## Winslow Park – Master Plan Narrative

2/28/2025

### **Code Compliance and Comment Response**

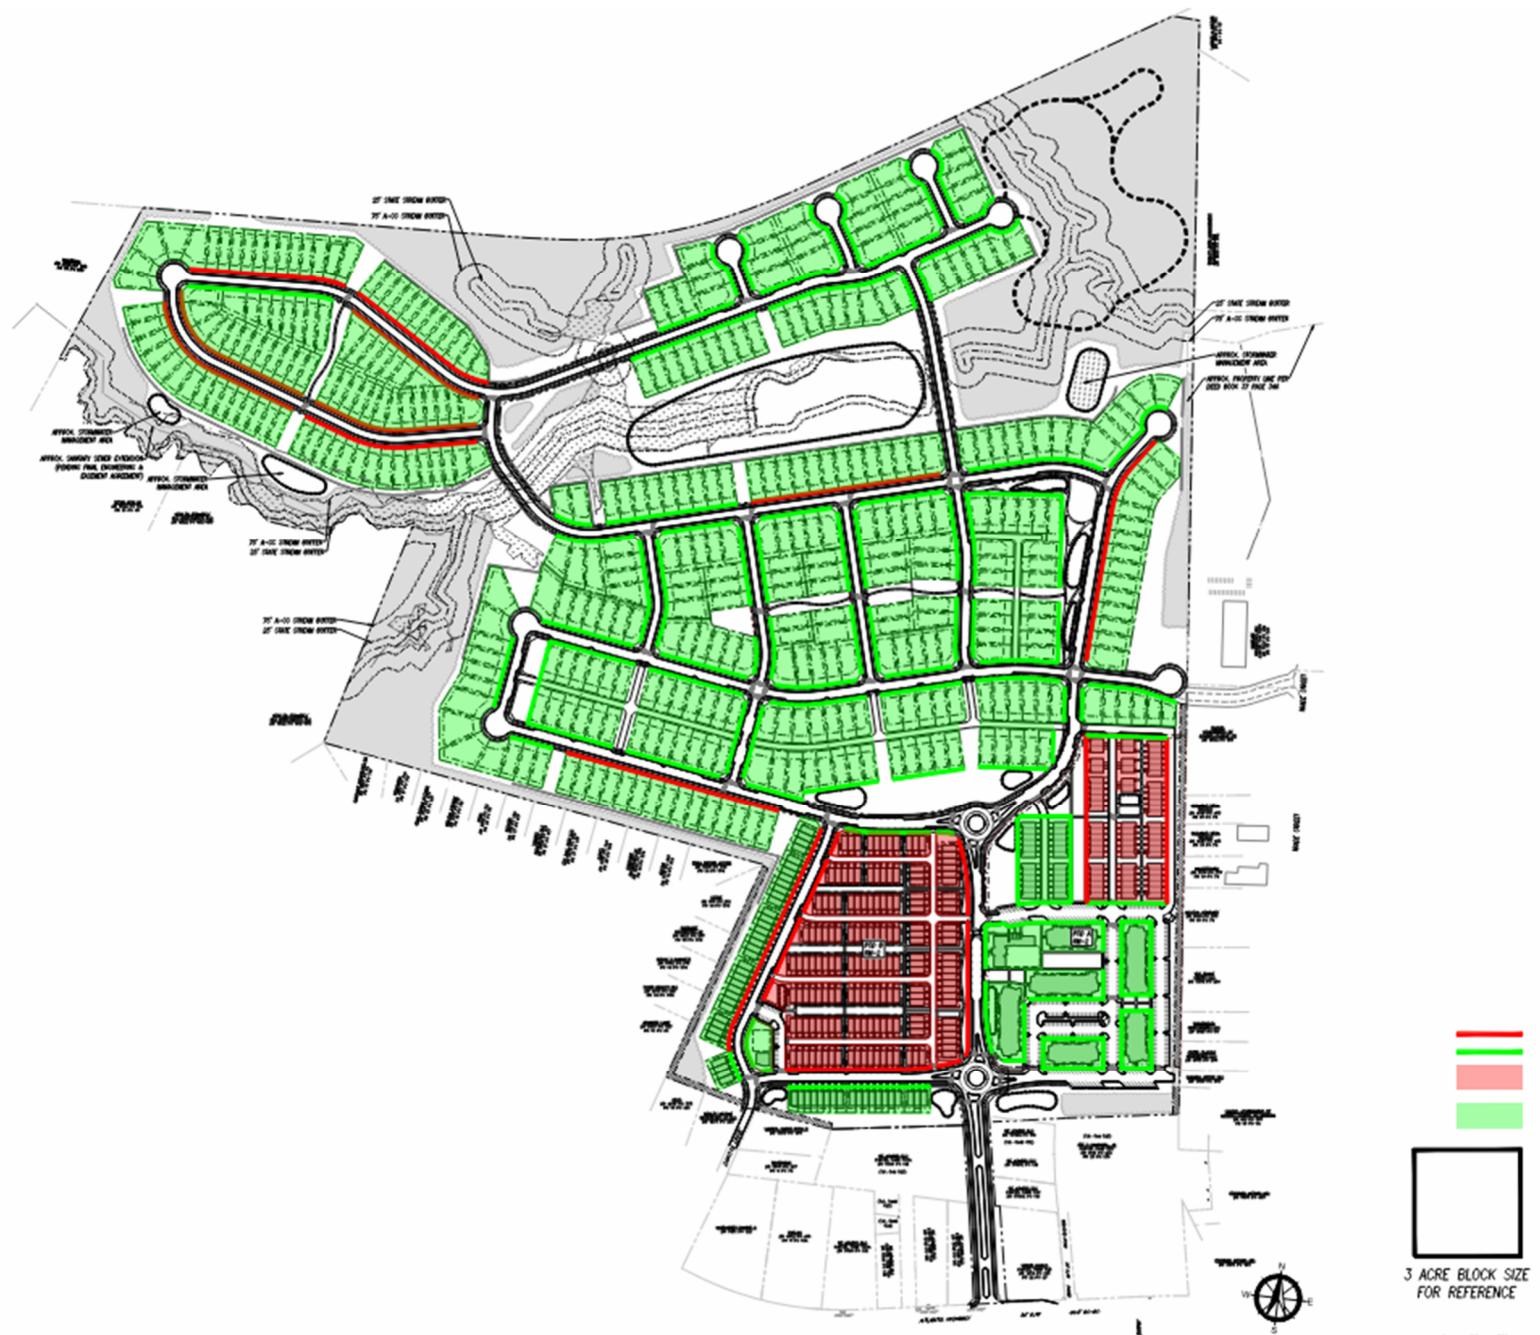
20. *In contrast to the preliminary site plan, the segment of Street 'B' (shown to be public) east of the roundabout is now shown to have diagonal on-street parking. This arrangement is not deemed to be safe and the additional pavement area and striping needs over those of parallel parking is an increased maintenance burden.*

21. *If Street 'B' is to be public, it needs a cul-de-sac at the eastern end to facilitate vehicles being able to turn around without backing up.*

This segment is now depicted as private.

This segment is now depicted as private.
